POWER-UNITS No.53A AND No.53B
10V 0·25A DC
SUPPLY FROM 50Hz AC MAINS

N 631
ISSUE E

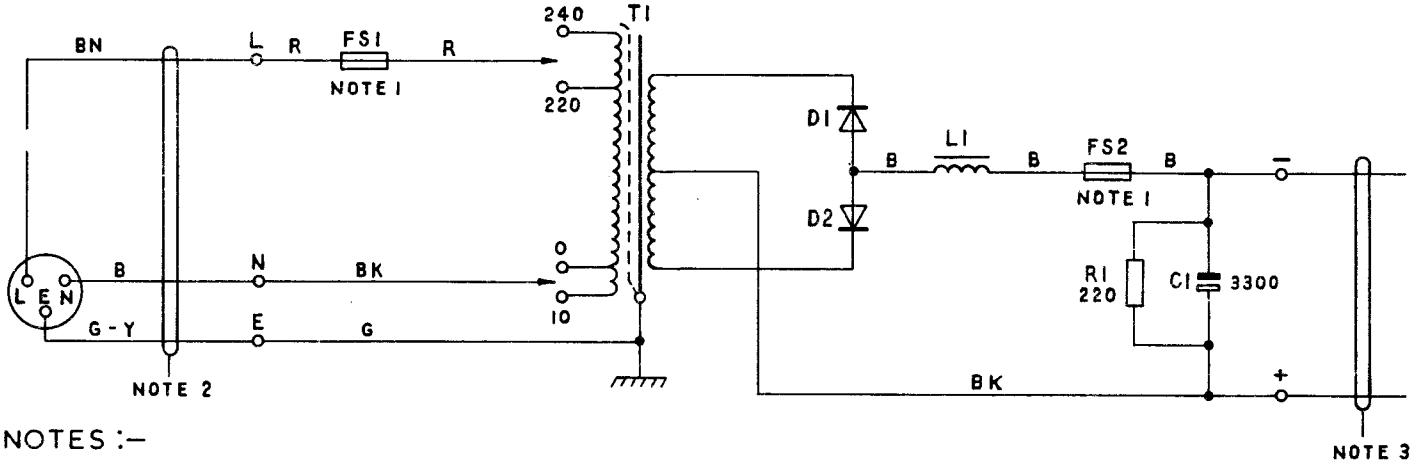
PO TELECOMMS HQRS PAPER :-W DISTN :- GENERAL			
	E	NEW FORMAT. TRANSFORMER 200V TAPPING REMOVED WIRE COLOURS AND CAPACITOR VALUE CHANGED. NOTES 2&3 AMENDED . NOTE 4 ADDED. 53B INTRODUCED D.L.W. TD 7.2.3	12·4·77
	D	NEW FORMAT KMA	12·7·66
